TEG-084

# Injury Criteria for Tibia - JAMA Proposal -

The Japan Automobile Manufacturers Association Inc.  
Pedestrian Safety WG

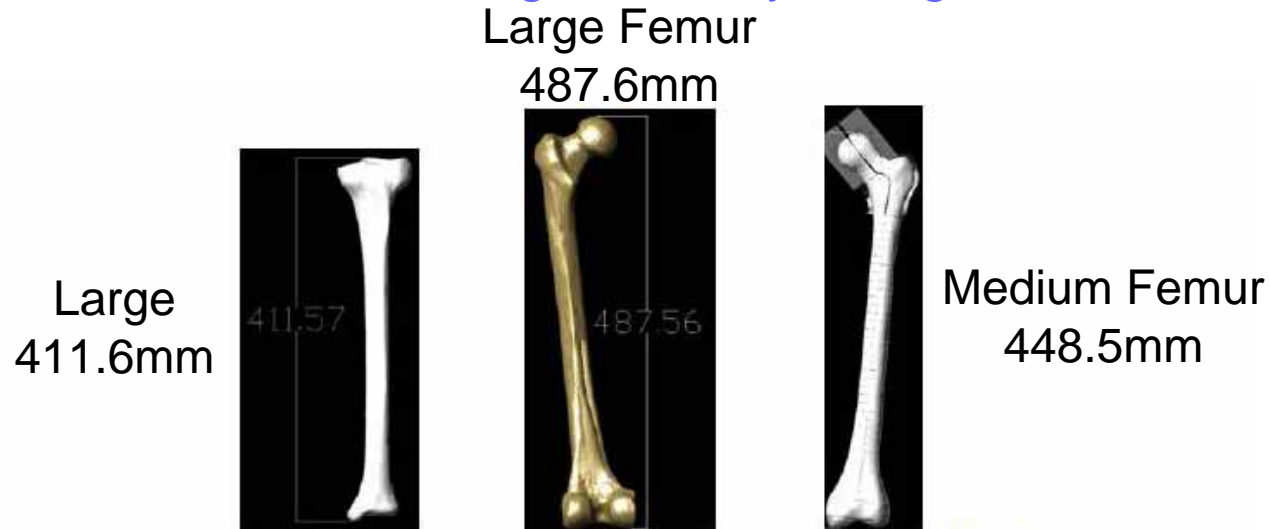
Reference Tibia Length used by Kerrigan et al.

- Reference tibia length used by Kerrigan et al. (2004) = **378.7 mm**
- Diffrient et al. (1993) : Tibia length for 50<sup>th</sup> percentile male = **411 mm**
- UMTRI data : Length between lateral malleolus and tibiale (x, z resultant) = **404.36 mm**
- A human tibia model shows tibia length is larger than UMTRI dimension

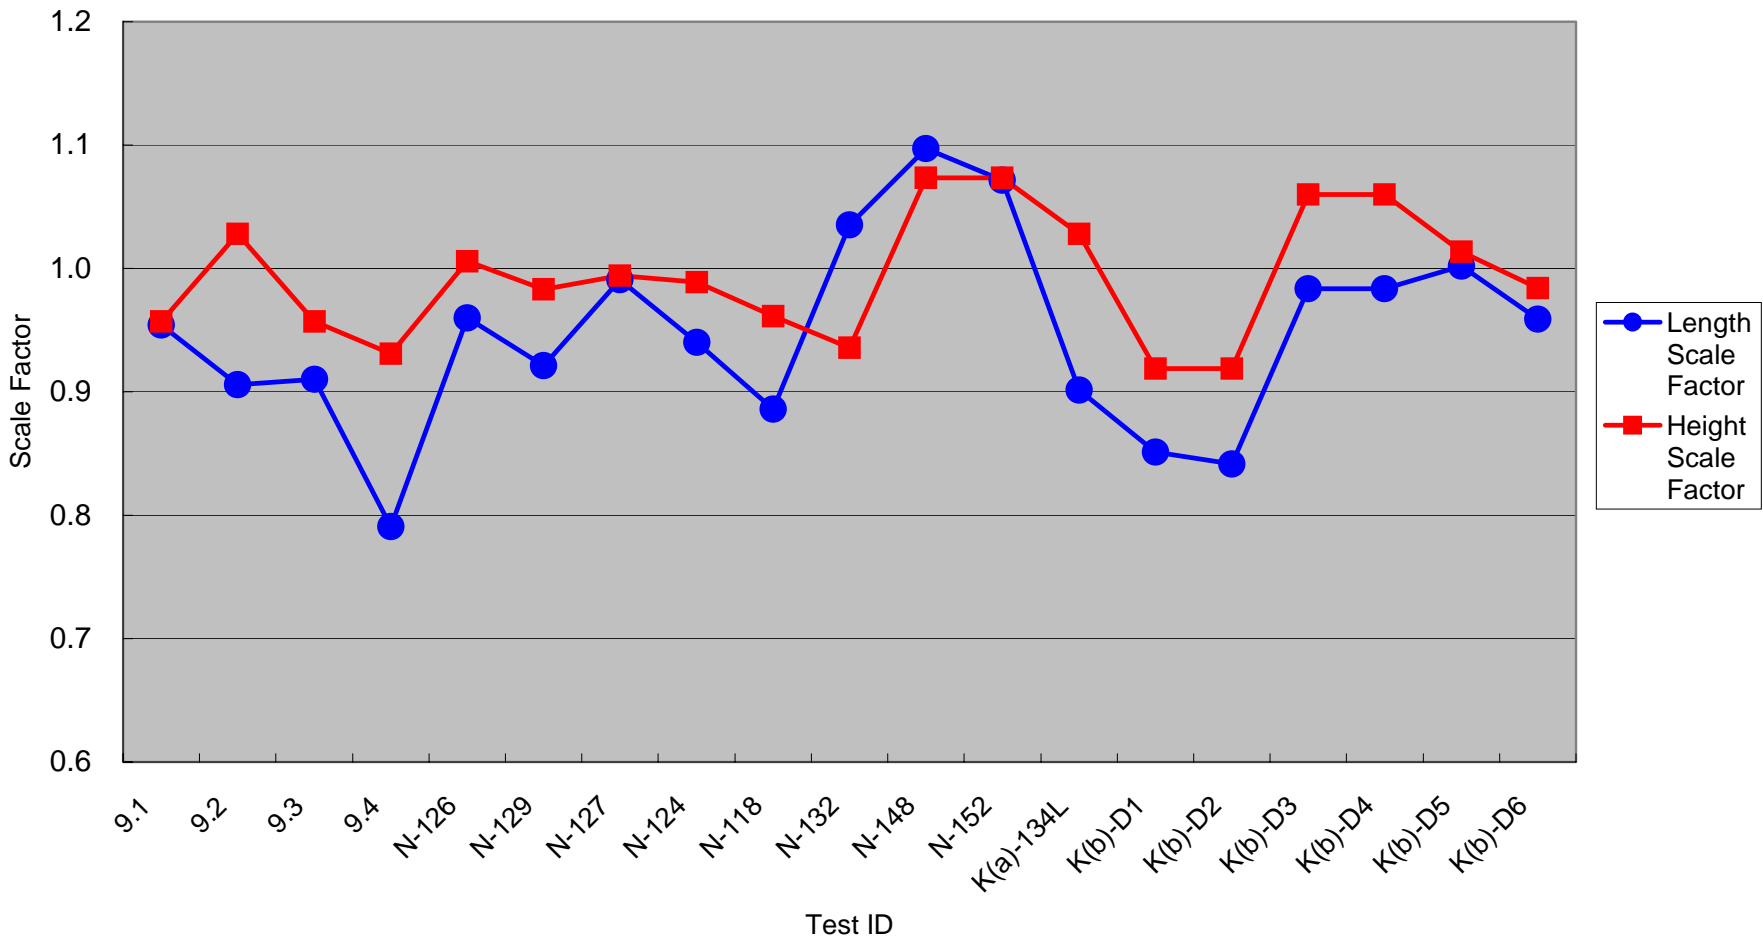
- Tibia length should be highly correlated with height
- Compare tibia length scale factor with height scale factor

Tibia length scale factors biased towards smaller numbers relative to height scale factors

Results of Survival Analysis for Original, Option-1 and Option-2 Datasets

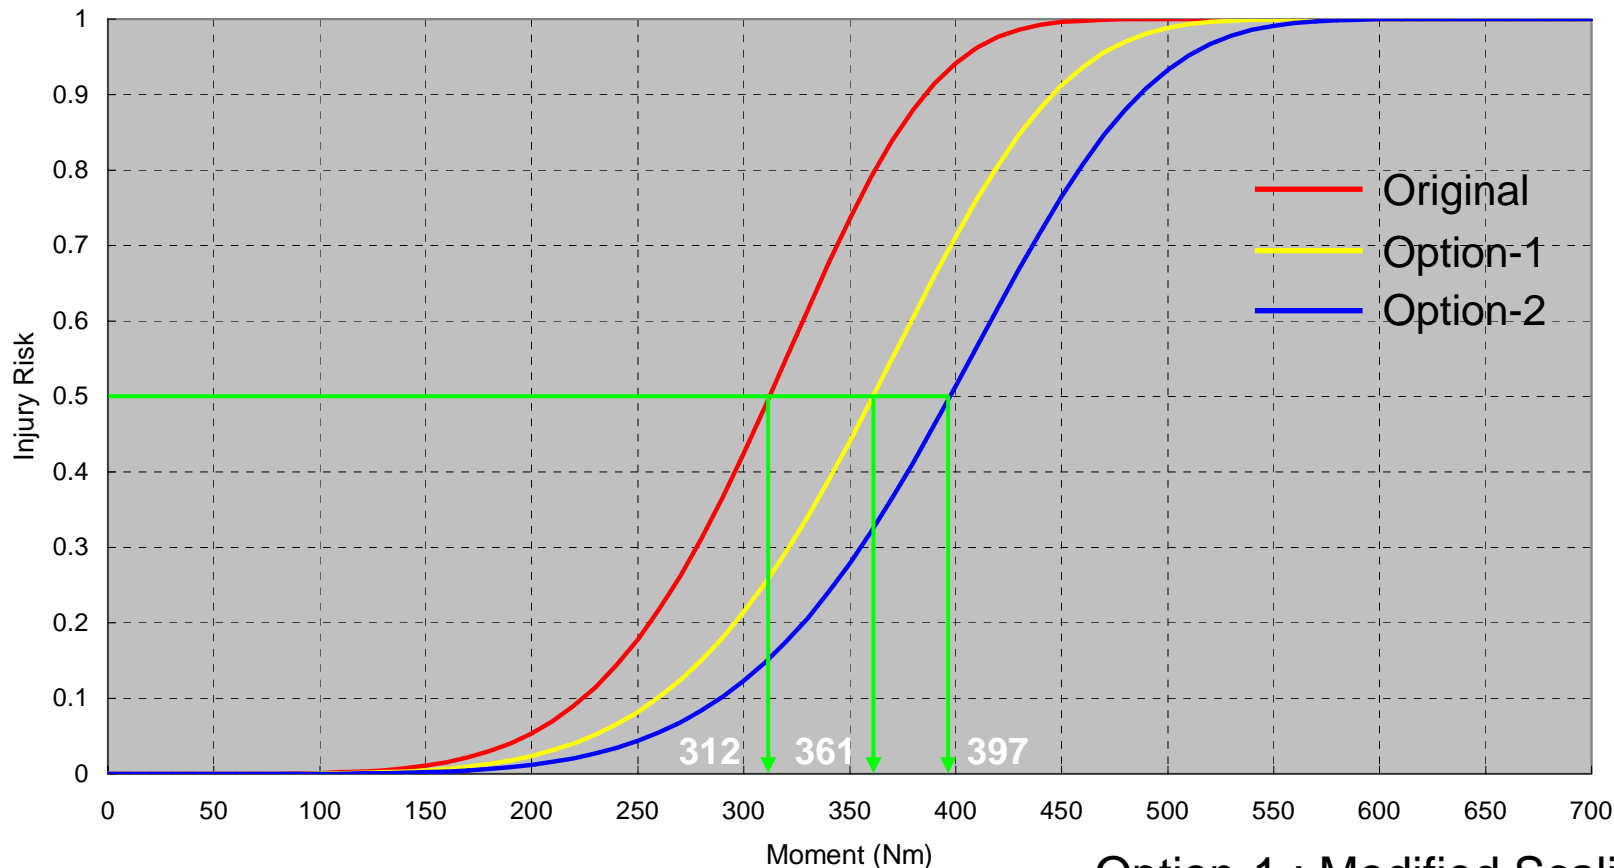
Case	Intercept	Scale	A	B	M50%
ORG	5.80766352	0.17571234	5.69112	33.05211	312
Option-1	5.953058	0.1753883	5.7016346	33.9421615	361
Option-2	6.046711	0.1689358	5.91940844	35.7929521	397

- Proposed bending moment threshold for human tibia : **361 Nm**
- Flex-GTR tibia bending moment threshold needs to be investigated based on the response correlation between the Flex-GTR and human lower limb
